MEMORANDUM

TO: Steve Ogle, Technical 1 Engineer
Boise Regional Office

FROM: Tina Kurtz, Scientist 1
Technical Services

SUBJECT: The Idaho Department of Correction Wastewater Reuse Permit Application
Review -- LA-000088-03 (Municipal Wastewater Facility)

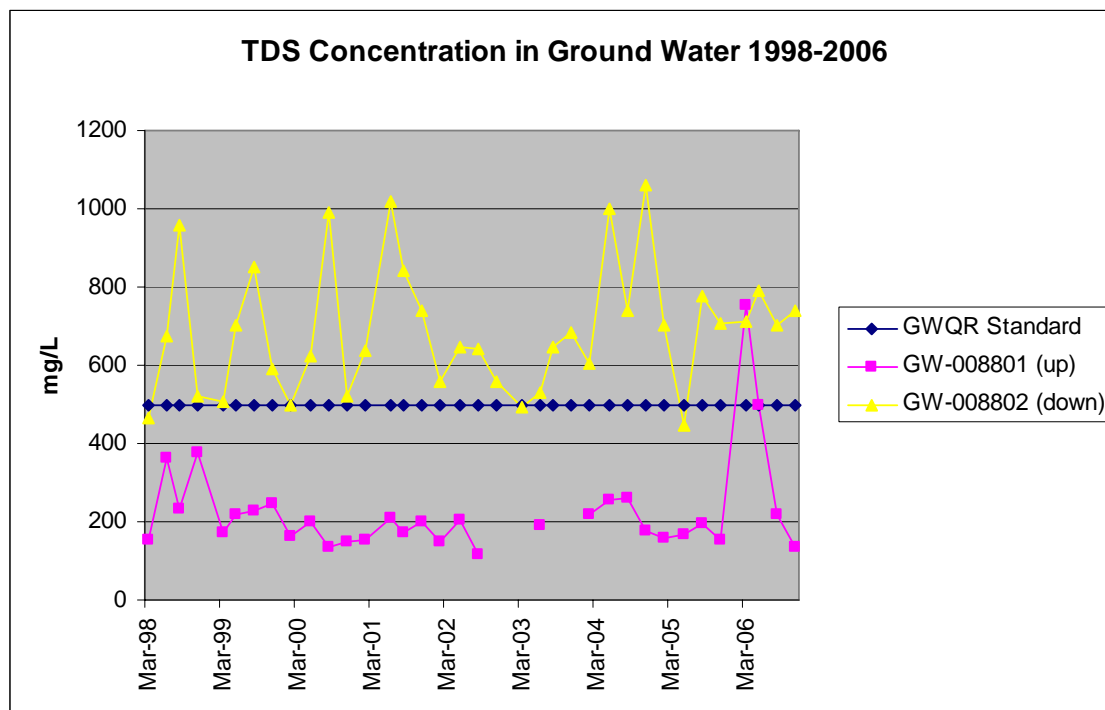
When this site was last re-permitted the sodium levels were found to be very high at the Valley Site, between 372 mg/L and 423 mg/L (DEQ, 1998). This can be problematic, given that sodium disperses clay and organic matter, thereby degrading soil structure and reducing macropore space, which consequently leads to soils that are poorly aerated and have reduced permeability to water (DEQ, 2007). During the course of the last permit cycle the facility has been sampling for the sodium absorption ratio (SAR) in order to provide information on the comparative amounts of sodium, calcium, and magnesium in the soil. The average SAR for the Valley Site from 1998-2006 was between 0.16 and 0.24, which would be considered low or slight, and levels have remained relatively constant, showing no definitive upward or downward trends (DEQ, 2005). SAR levels at the East Site were also well within the low range, with an average of 0.54. However, given the Valley Site's past history with high sodium levels staff recommends that SAR be sampled at the first and last year following the issuance of the new permit.

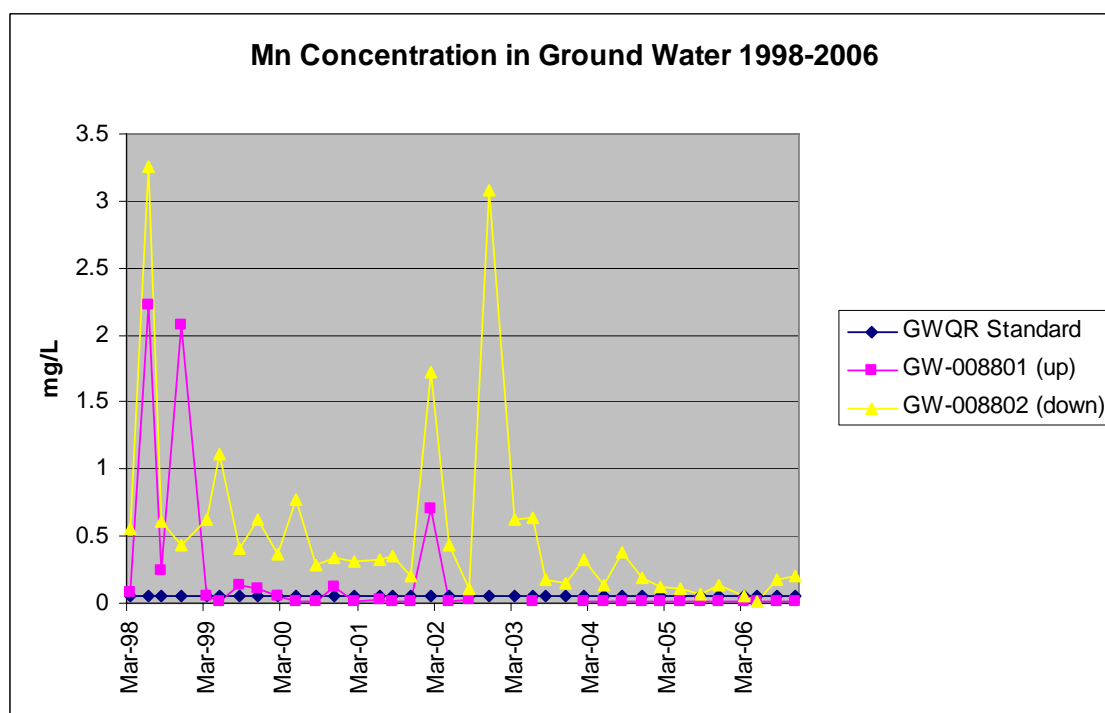
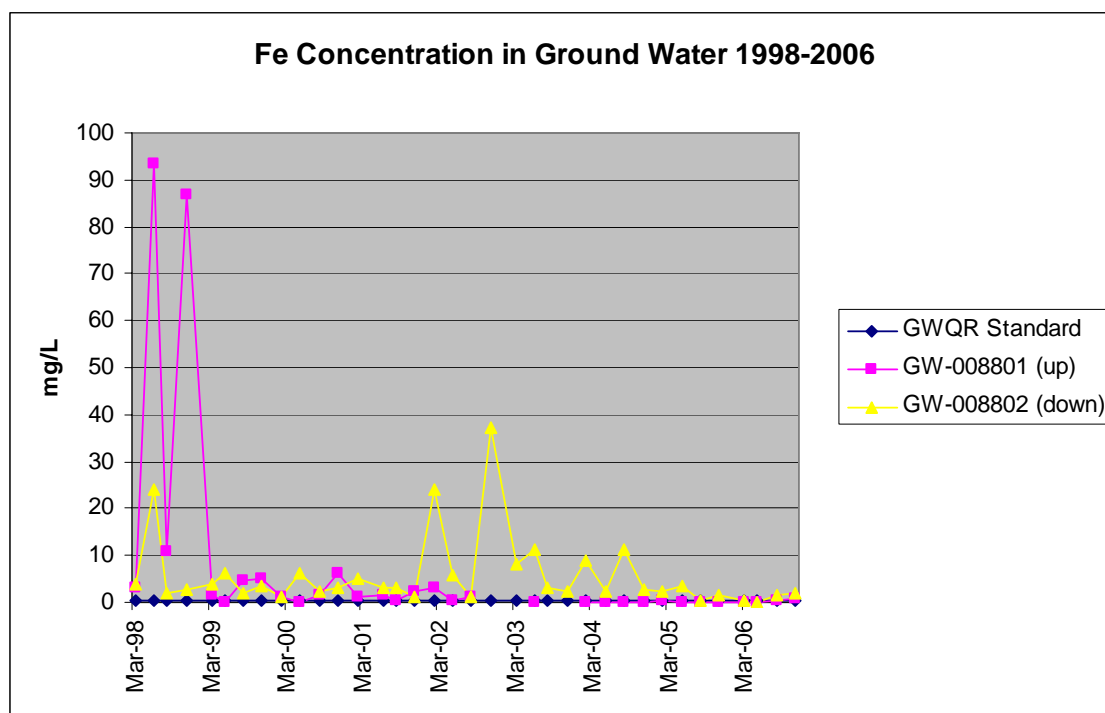
When the East Site was initially put into service in 1998 there was some concern over the fact that the soil salinity was at the high end of the generally accepted levels, with an average of 5520 umhos in the upper 22 inches of soil strata (DEQ, 1998). Since 1998 the electrical conductivity of the site has been much lower, possibly due in part to the leaching caused by land application, at an average of approximately 454 umhos/cm with a minimum of 86 umhos/cm in 2001 and a maximum of 1050 umhos/cm in 2003. These values have fluctuated somewhat over the course of the permit term, as evidenced by the graph above, and are still slightly higher than those of the Valley Site but remain well below the 2,000 umhos/cm level which has been known to restrict the yield of sensitive crops. It is recommended that electrical conductivity continue to be monitored in order to ensure that levels remain within the acceptable range.

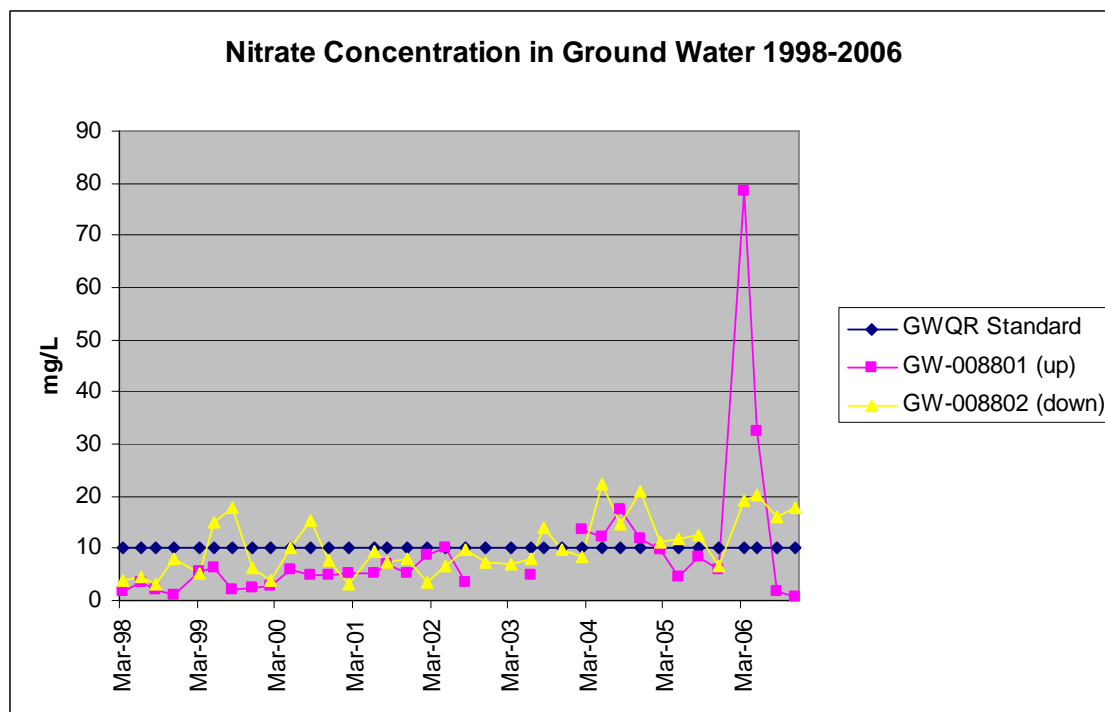
As evidenced by the graphs above, the facility's down-gradient well has been fairly consistent in its exceedence of the Ground Water Quality Standard (IDAPA 58.01.11.200.01.b) for total dissolved solids (TDS) of 500 mg/L during the permit cycle. Given the significantly lower TDS concentrations detected in the up-gradient well, it is probable that these levels are reflective of impacts from the land application site. In order to fulfill the conditions of Compliance Activity CA-088-03 of LA-000088-02 the facility performed seepage tests on the lagoons at the Valley Site in June of 2000. While the test results indicate that the lagoons met the DEQ requirements of less than 0.25 inches per day for the treatment lagoon and 0.125 inches per day for the storage lagoon, it is still possible that a portion of the TDS impacts seen in GW-008802 could be attributed to lagoon seepage. Staff recommends that the lagoons at both the Valley and East Sites be tested to determine current seepage rate losses (See Section E, CA-088-02 of the draft permit).

In addition to the elevated TDS levels, the down-gradient well has been almost universally in exceedence of the secondary constituent standards (IDAPA 58.01.11.200.01.b) for both iron and manganese. However, the up-gradient well also shows high concentrations of these constituents at times as well so it is difficult to definitively trace these levels to the land application site. It is possible that many of these exceedences could be due to high levels of turbidity in the wells, but without any dissolved samplings, the extent to which turbidity is a contributing factor is hard to ascertain. Staff recommends that the facility sample for dissolved Fe and Mn when total results exceed the aforementioned ground water standards in order to more fully determine the role of turbidity in the site's high ground water constituent levels.

Historically, nitrate levels have fluctuated rather widely in both the down-gradient and up-gradient well on the site. However, as depicted in the graph above, there has been a distinct upward trend in nitrate levels over the past 2-3 years, particularly in the down-gradient well. The

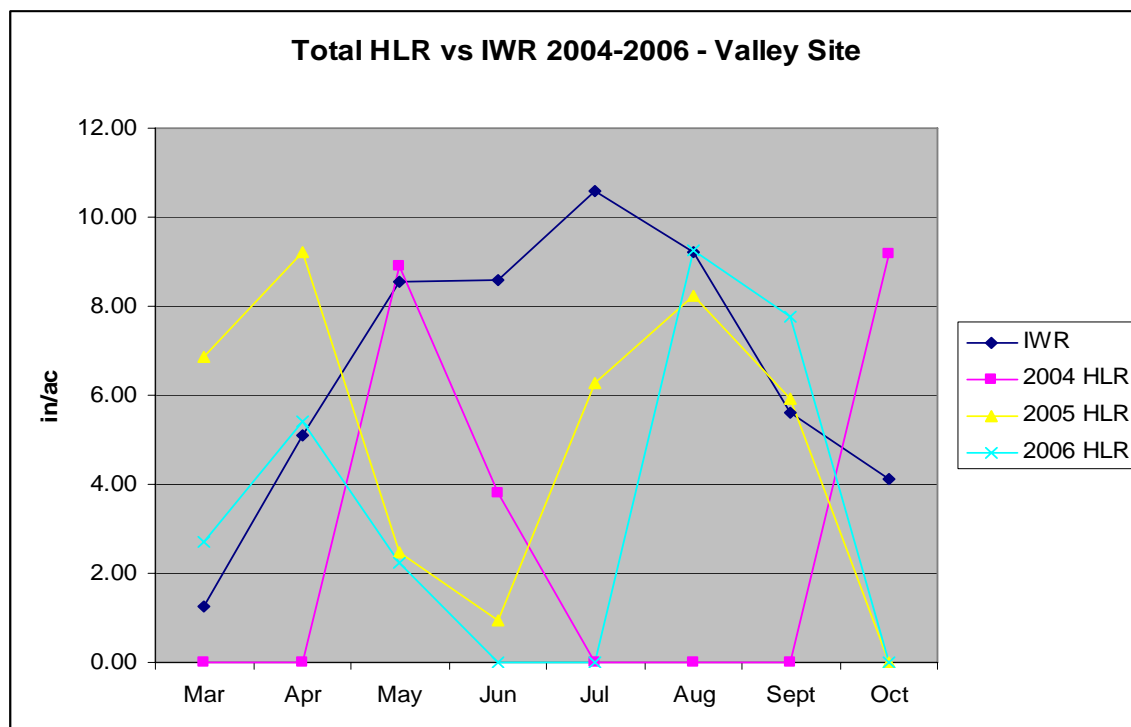
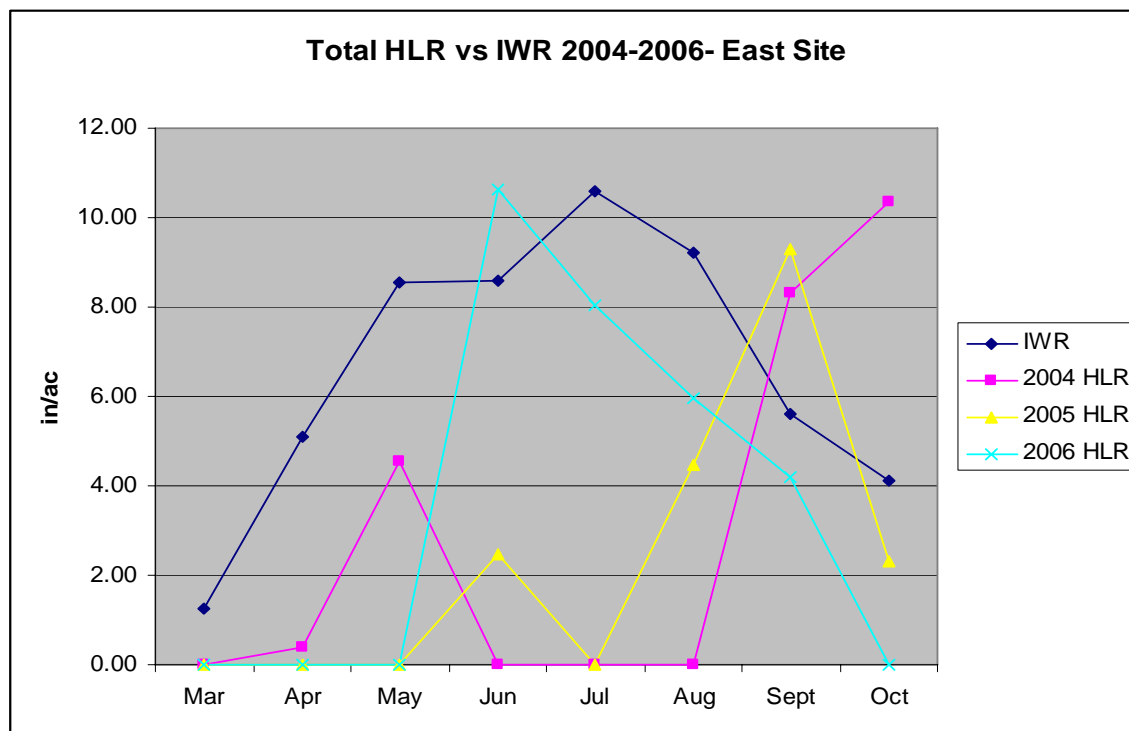
As evidenced by the above plots, not only are the crops not receiving an adequate amount of water during the growing season, what water they do receive is not being applied at the optimum times. The large deficits seen in June, July, and August can be particularly detrimental to crop health and thereby restrict both crop yield and nutrient uptake. Crop yields for this facility have consequently been rather low. The USDA National Agricultural Statistics Service gives average crop yield for irrigated alfalfa hay in Ada county between 1998-2005 as 5.0 ton/ac (USDA, 2007) whereas average yields have been 3.1 ton/ac at the Valley Site and only 2.0 ton/ac at the East Site (IDOC 1998-2006). Staff recommends that the IWR be calculated using 30 year average data for the area and that sufficient supplemental irrigation water be added to the wastewater to meet these requirements; thereby improving both crop yield and nutrient uptake.
